International Special Review District Board meeting request letter

Project Name: T-Mobile SE03494E Weller King/Fujisada Condos
Project Address: 510 6TH AVE S
Parcel Number: 2662650000

SDCI Project Numbers: 000655-22PA (Pre-App), DONH-COA-00470 (DONH COA),
3039261-LU (MUP), 6883695-CN (Const.)

RE: 510 6th Ave, Seattle, WA
T-Mobile: SE03494E Weller King-Fujisada
Radio Frequency Engineering Analysis Regarding Antenna Placement

Exhibit 1

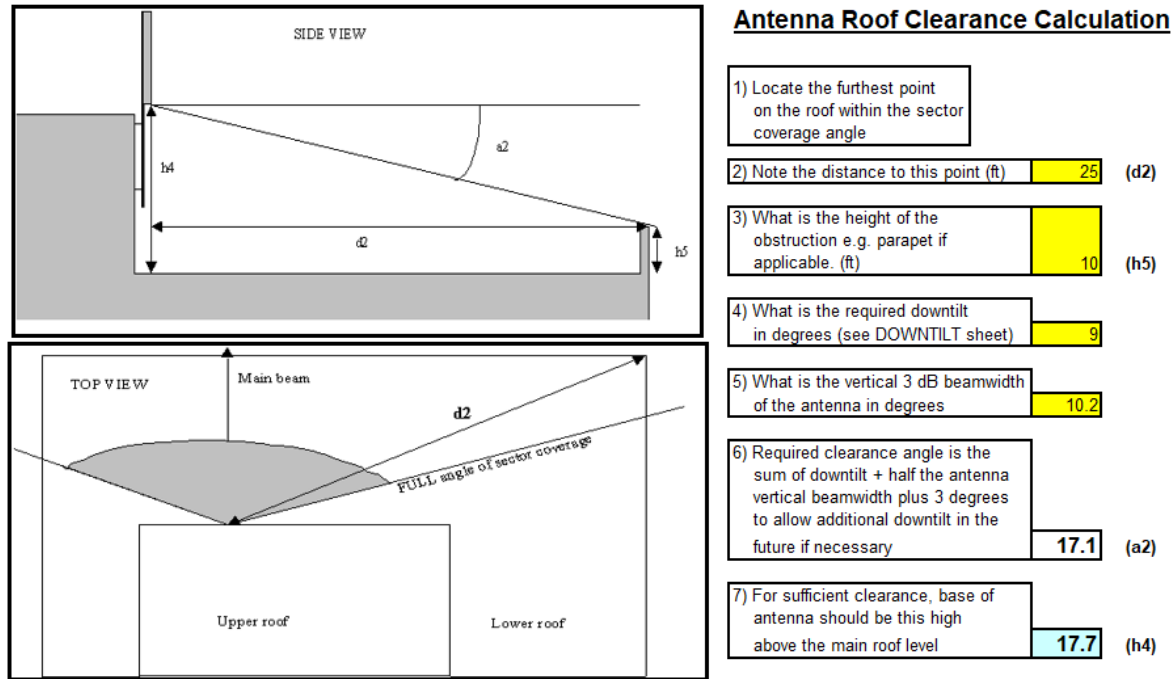
Exhibit 1 below illustrates the equation of the height required above the roof to clear the penthouse as an obstruction:

This is illustrative of the calculation that is required and does not demonstrate the actual calculation at this site.

The calculation takes into account the antenna to be utilized which in this case has a 10.2 vertical beamwidth (the largest vertical beamwidth of all proposed site antennas) and with a ten foot penthouse height above roof surface and a twenty-five foot setback from the penthouse, along with a nine degree of total downtilt, the requirement is for an antenna that is eighteen (18) feet above the roof (base height) or a twenty six foot tip height at a minimum which would be 106'-1" AGL which is neither allowable by code nor is it feasible. Based upon the calculations, the proposed relocation to the penthouse will eliminate any blockage that will occur so that the antenna can be fully utilized to provide coverage and capacity to the International District.
